## Memorandum

**Re:** Desert Springs Church, Administrative Amendment Request Resubmittal  
– PR-2021-005784, SI-2021-01136

### Project #PR- 2021-005784

**D2 TYPICAL CURB AND GUTTER SECTION**  
SCALE: NOT TO SCALE

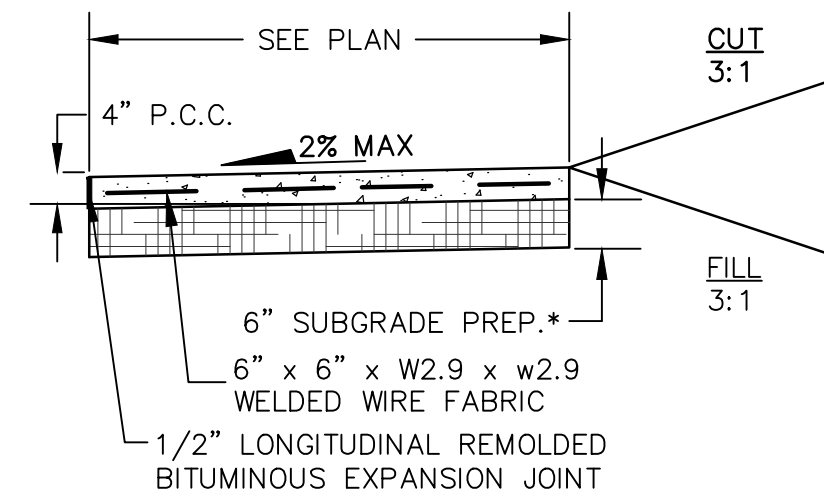
5. Label new asphalt parking lot as an asphalt surface if this is the intent, and add a keyed note calling out all curb. Curb that separates the parking lot from the landscape islands and pedestrian ways shall be between 6" to 8" high.  
[Curb detail is shown on the grading and drainage plan. We've added additional notes indicating that the curb is 6" high.](#)

6. Add curb and sidewalk details as applicable. 2% cross slope maximum should be labeled for any new sidewalk.  
[Curb and sidewalk details are added to the grading and drainage plan. Cross slope is identified.](#)

**GRADING AND DRAINAGE PLAN**

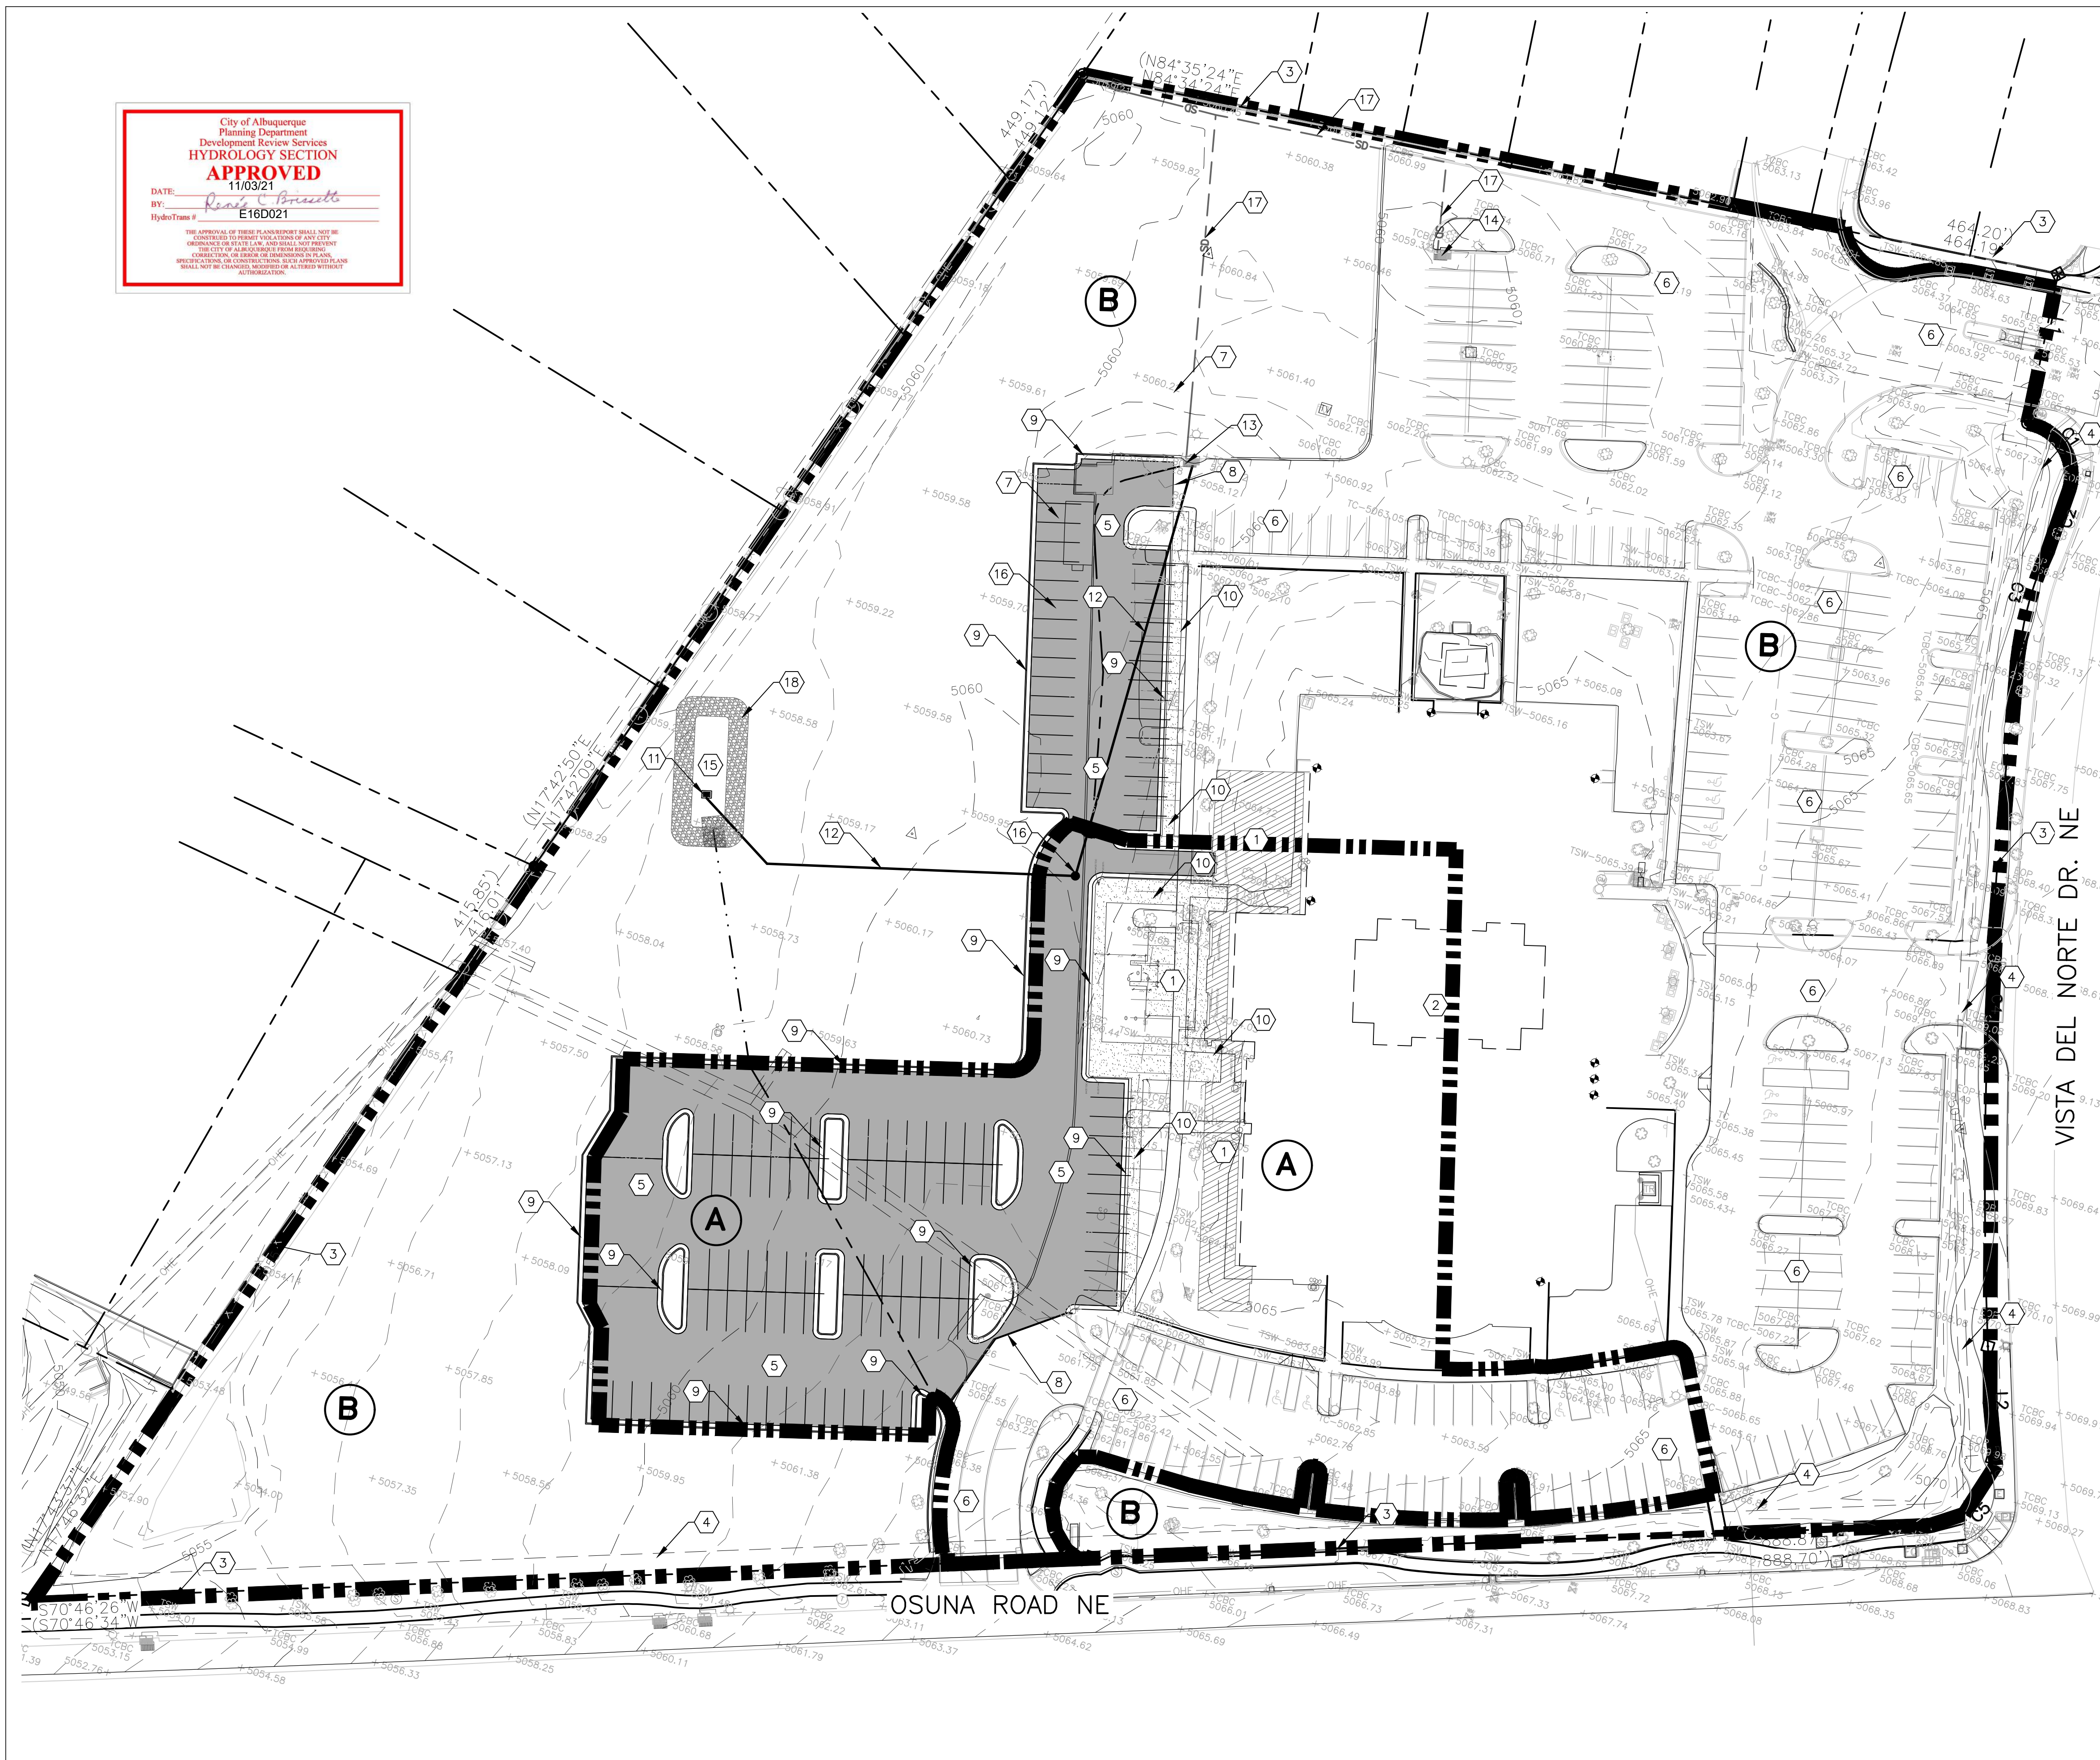
Based upon the information provided in your submittal received 09/08/2021, the Grading & Drainage Plan is approved for Grading Permit and Paving Permit. Once the grading and paving of the project is complete, please provide an as-built for Hydrology’s records.

Please provide the Drainage Covenant with Exhibit A for the detention pond per Article 6-15(C) of the DPM prior to Permanent Release of Occupancy. Please submit the original copies along with the \$ 25.00 recording fee check made payable to Bernalillo County to Marion G. Velasquez ([mgvelasquez@cabq.gov](mailto:mgvelasquez@cabq.gov)) on the 4th floor of Plaza de Sol.
